AERONAUTICAL CHARTING FORUM
Instrument Procedures Group
October 27, 2009
HISTORY RECORD

FAA Control # 09-02-291

Subject: Straight-in Minimums NA at Night

Figure 3-2a. Standard Visual Area.

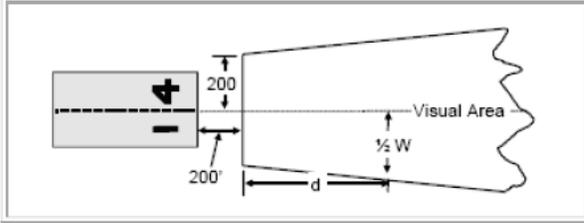
As can be seen in these excerpts from TERPS, the STRAIGHT-IN and OFFSET assessment areas are larger in width than the STANDARD (circling) assessment area:

Further, it appears that this discrepancy might actually increase the risk of a low altitude encounter with unlighted low, close in obstacles since the circling maneuver by nature is more likely to encounter obstacles at the fringes of the visual obstacle assessment area. This is especially true for those obstacles that lie between the lateral limits of the STANDARD area and the STRAIGHT-IN or OFFSET areas.

Figure 3-2c. Offset Visual Area.

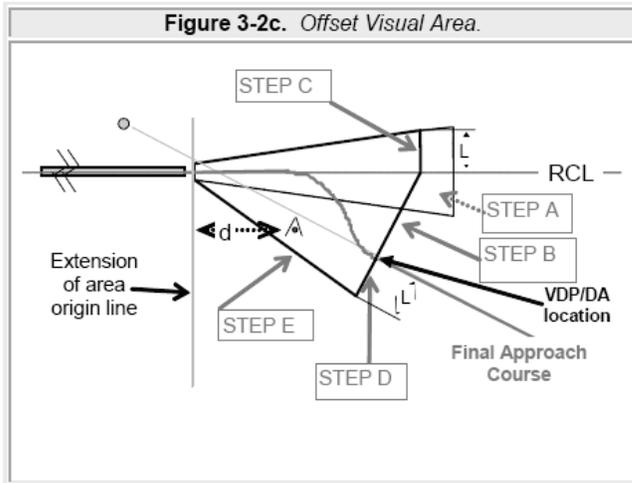
It is likely that the application of the OFFSET assessment area has located offending obstacles that are otherwise missed with the application of the STANDARD assessment area. Perhaps the difference results from nothing more than the presence of lights, or lack thereof, on the affected obstacles.

RNAV (GPS) RWY 28

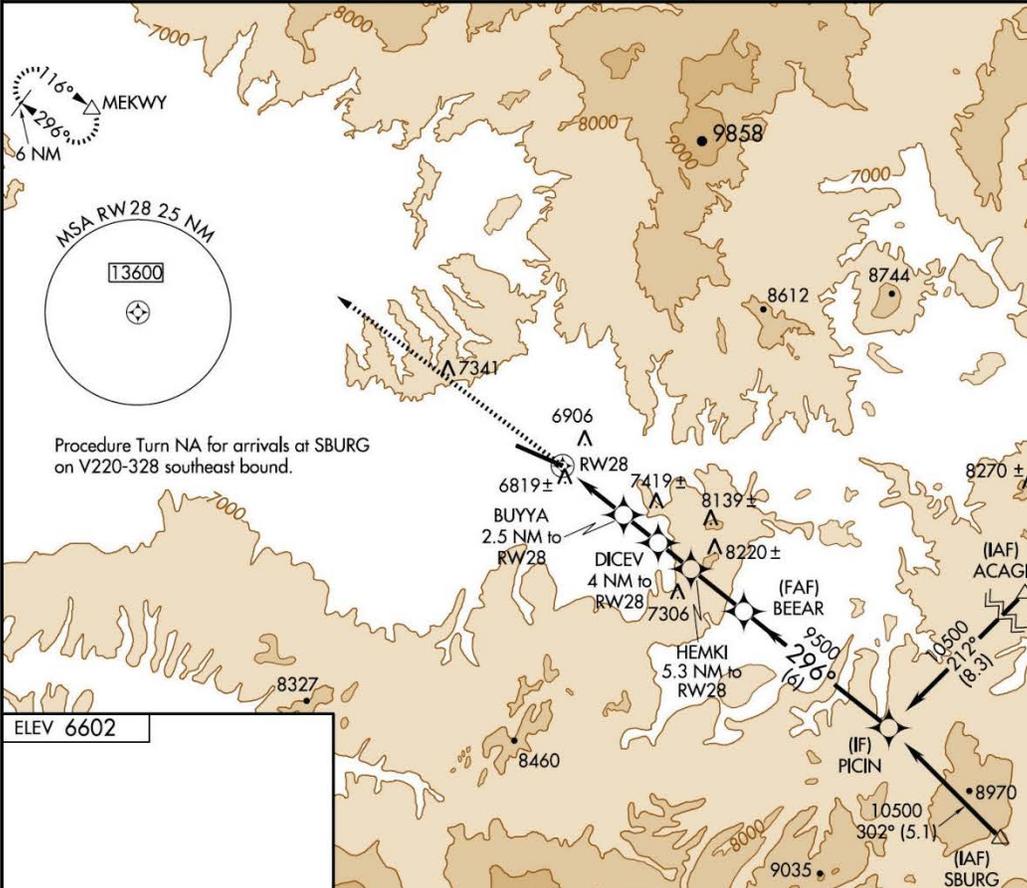
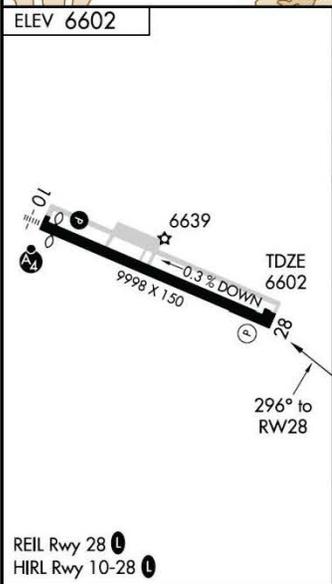
On the two examples provided, HDN and 12J, the use of the straight-in landing minimums are prohibited at night, which would indicate that the OFFSET assessment area's 20:1 slope has been penetrated (OFFSET is used because in both cases, the final approach course is not aligned with the runway centerline). However, as two different approaches to this airport illustrate, circling to the same runway is not prohibited even though the straight-in approach is prohibited. The only logical explanation is the differing dimensions of the assessment areas for straight-in minimums (OFFSET area) in the case of HDN and 12J) and circling minimums (STANDARD area) to the applicable runway as allowed for by the NOTE shown above.

NOTE: While the HDN RNAV (GPS) Runway 28 approach straight-in minimums have been NOTAM'd N/A, the 12J VOR/DME Runway 30 approach remains effective (see attached NOTAMS).

NA GPS or RNP-0.3 required. DME/DME RNP-0.3 NA. Straight in minimums NA at night. MISSED APPROACH: Climb to 10000 direct MEKWY WP and hold.
